Title: STAGE 1 ROAD SAFETY AUDIT

Proposed Residential Development at Hacketstown, Skerries.

Client: DBFL/Land Development Agency

Report reference: 1389R01

Drawing 190170-DBFL-RD-SP-DR-C-1002 Rev P02.01, Road Marking & Signage Layout Plan, Raised Tables throughout the development.

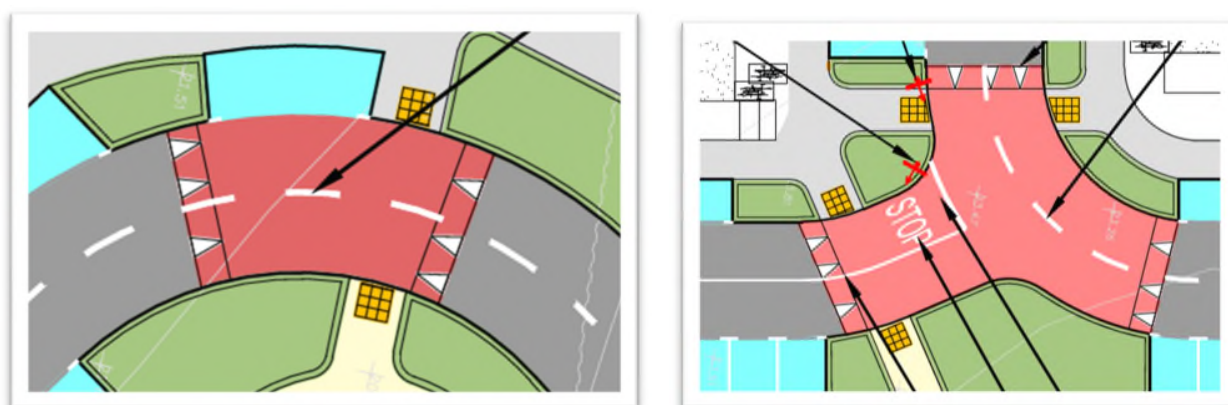
It is proposed to provide raised tables throughout the development including at sharp changes in direction. There is a risk that drivers will cut the corners and mount the adjacent verge/footpath if the raised tables are at the same height. This could be a risk for pedestrians.

It is recommended that suitable vertical segregation between the top of the raised table and the top of the kerbs be provided.

| Paragraph No. in Safety Audit Report | Problem accepted (yes/no) | Recommended measure accepted (yes/no) | Alternative measures (describe) | Alternative measures accepted by Auditors (Yes/No) |
|--------------------------------------|---------------------------|---------------------------------------|--|--|
| 3.5 | Yes | Yes | | |

Drawing 190170-DBFL-RD-SP-DR-C-1002 Rev P02.01, Road Marking & Signage Layout Plan, Raised Tables throughout the development.

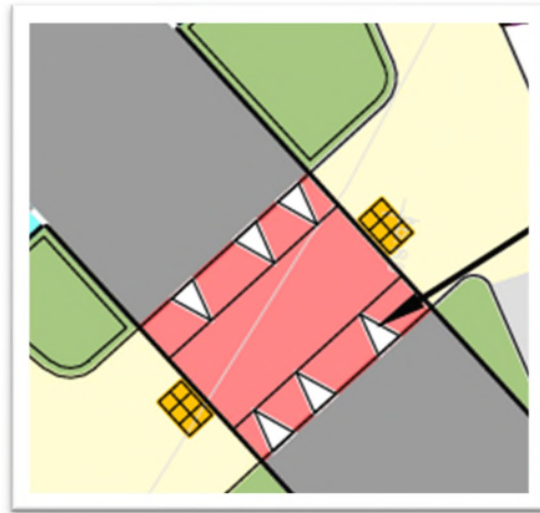
The raised tables throughout the development generally have associated uncontrolled pedestrian crossings. It is unclear if the crossings are dished at the tactile paving only or across the entire footpath width. If there are areas where the footpath is flush with the raised table and without tactile paving a blind or partially

sighted pedestrian may inadvertently enter the carriageway. This could lead to collisions with passing vehicles. In addition, some pedestrian crossing locations appear to be narrow (three tiles i.e. 1200mm) which may not cater for the volume of users.

It is recommended that tactile paving be provided over the entire width of dropped kerbs/flush kerbs with the raised tables and that the area of dropped kerb be of sufficient width to match the demand.

| Paragraph No. in Safety Audit Report | Problem accepted (yes/no) | Recommended measure accepted (yes/no) | Alternative measures (describe) | Alternative measures accepted by Auditors (Yes/No) |
|--------------------------------------|---------------------------|---------------------------------------|--|--|
| 3.6 | Yes | Yes | | |

Drawing 190170-DBFL-RD-SP-DR-C-1002 Rev P02.01, Road Marking & Signage Layout Plan, Perpendicular Parking outside Block A2.

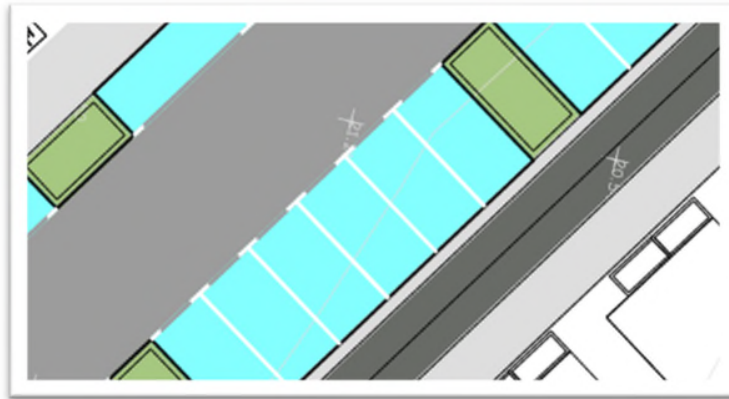
It is unclear how vehicle occupants who park in the perpendicular parking spaces outside Block A2 can access the residential units if they are pushing buggies or are somewhat mobility impaired. The gaps in the parking will be landscaped and it is assumed that there will be a high kerb at the buffer zone between the parking spaces and the two-way cycle track.

It is recommended that convenient access routes be provided without steps or trip hazards to cater for the mobility impaired. A similar situation exists at other Blocks within the development.

| Paragraph No. in Safety Audit Report | Problem accepted (yes/no) | Recommended measure accepted (yes/no) | Alternative measures (describe) | Alternative measures accepted by Auditors (Yes/No) |
|--------------------------------------|---------------------------|---------------------------------------|--|--|
| 3.7 | Yes | Yes | | |

Drawing 190170-DBFL-RD-SP-DR-C-1002 Rev P02.01, Road Marking & Signage Layout Plan, Shared use Street between Block B1 and Block A2

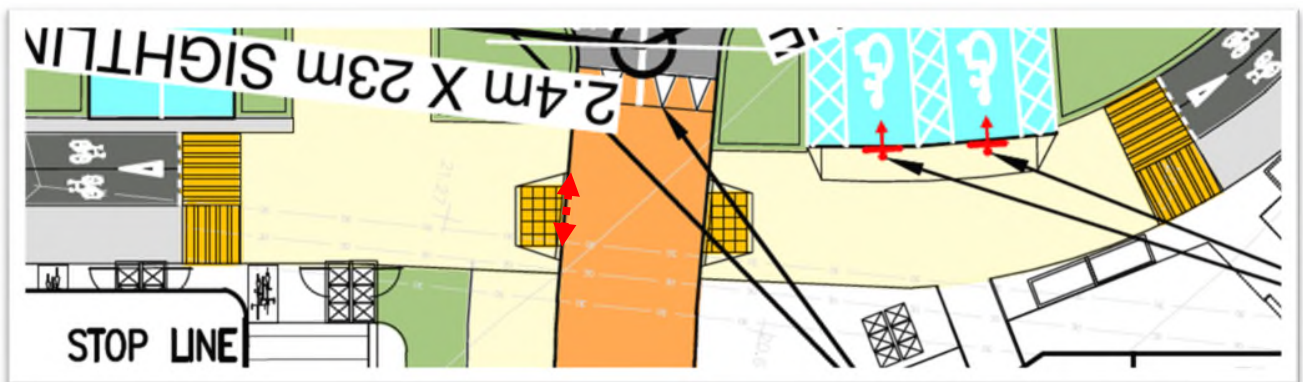
There is a proposed to provide a 2m wide uncontrolled crossing of the shared street. This may lead to collisions between two-way cyclists and pedestrians as they try and share the same space.

It is recommended that a wider crossing area be provided.

| Paragraph No. in Safety Audit Report | Problem accepted (yes/no) | Recommended measure accepted (yes/no) | Alternative measures (describe) | Alternative measures accepted by Auditors (Yes/No) |
|--------------------------------------|---------------------------|---------------------------------------|--|--|
| 3.8 | Yes | Yes | | |

Drawing 190170-DBFL-RD-SP-DR-C-1002 Rev P02.01, Road Marking & Signage Layout Plan, Landscape Path.

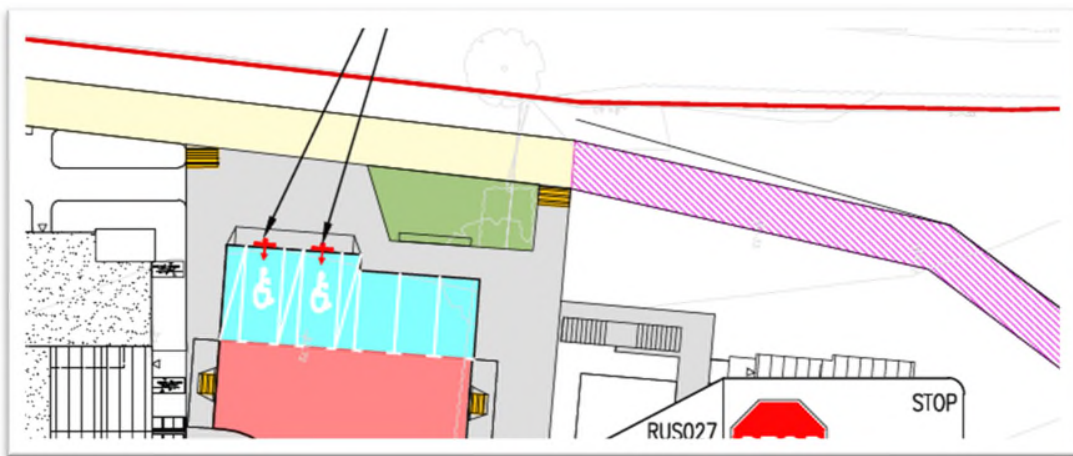
It is unclear if the landscape path is designed for cyclists. The landscape path joins the shared use pedestrian cycle route at the northern side of the site. If the path is unsuitable for cyclists it is unclear where they should travel once they reach the interface point. A lack of provision could lead to cyclists sharing with pedestrians and thereby increasing the risk of a collision.

It is recommended that cyclists be given a clear route to get to the link to Ballygossan Park.

| Paragraph No. in Safety Audit Report | Problem accepted (yes/no) | Recommended measure accepted (yes/no) | Alternative measures (describe) | Alternative measures accepted by Auditors (Yes/No) |
|--------------------------------------|---------------------------|---------------------------------------|--|--|
| 3.9 | Yes | Yes | | |

Drawing 190170-DBFL-RD-SP-DR-C-1002 Rev P02.01, Road Marking & Signage Layout Plan, Access onto Golf Links Road.

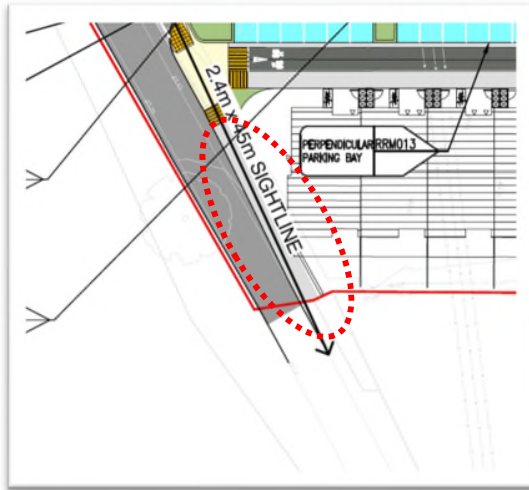
There will be a discontinuity in the footpath provision on Golf Links Road between the direct access and the Ballygossan Park access. Pedestrians will step into the carriageway where they will be at greater risk of being struck by a passing vehicle.

It is recommended that the footpath be made continuous along Golf Links Road.

If this is not feasible due to land ownership issues then the footpath should continue no further than the link to the internal network of footpaths and cycle tracks.

| Paragraph No. in Safety Audit Report | Problem accepted (yes/no) | Recommended measure accepted (yes/no) | Alternative measures (describe) | Alternative measures accepted by Auditors (Yes/No) |
|--------------------------------------|---------------------------|---------------------------------------|--|--|
| 3.10 | Yes | No | The footpath has been retained as it leads to/from a private side entrance to the rear | |

| | | | garden of the adjoining residential dwelling. The scheme proposals will deliver a number of alternative safe segregated high quality pedestrian routes through the proposed residential development which will accommodate the subject travel desire line for pedestrians seeking to gain access to destinations to the north. | Yes |
